Report: TAB Report
Function: Test, Adjust, & Balance
Date: 11/26/2025
Completed By: National TAB

PROJECT
12-08-25 QT #1439 MESA, AZ

Project: 12-08-25 QT #1439 MESA, AZ

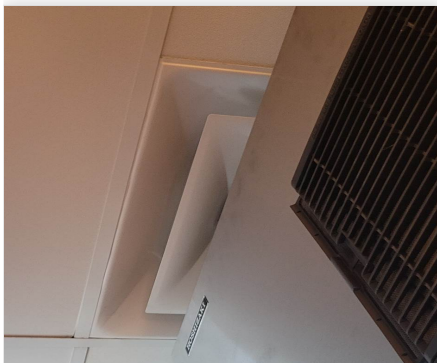
Issue Name : HOOD PERFORMANCE
Description : Hood is capturing at roughly 80% around the perimeter. Further testing needed to determine cause. Hood exhaust was increased to +8-10% over design (max allowed) but capture did not improve. Smoke escapes mostly from panel side(left), and a small amount from right-front. Based on other sites, diffuser style may be causing drafting around hood.
Created By : National TAB **Assigned To :** National TAB - Dan Hertenstein
Status : Open
Priority : Urgent **Asset Tag :** HD1
Originated Date : 12/10/2025 - Christine Weale - National TAB

Asset: EF2

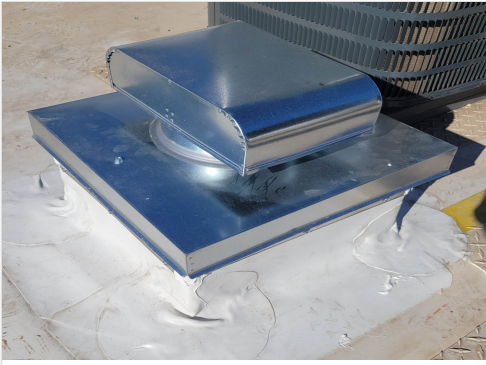
PER GC, INLINE FAN ADDED TO SERVE COMBI-OVEN GRILLE. FAN IS NOT ACCESSIBLE. UNABLE TO LOWER COMBI-OVEN GRILLE TO DESIGN, NOT ANTICIPATED TO CAUSE ANY ISSUE.
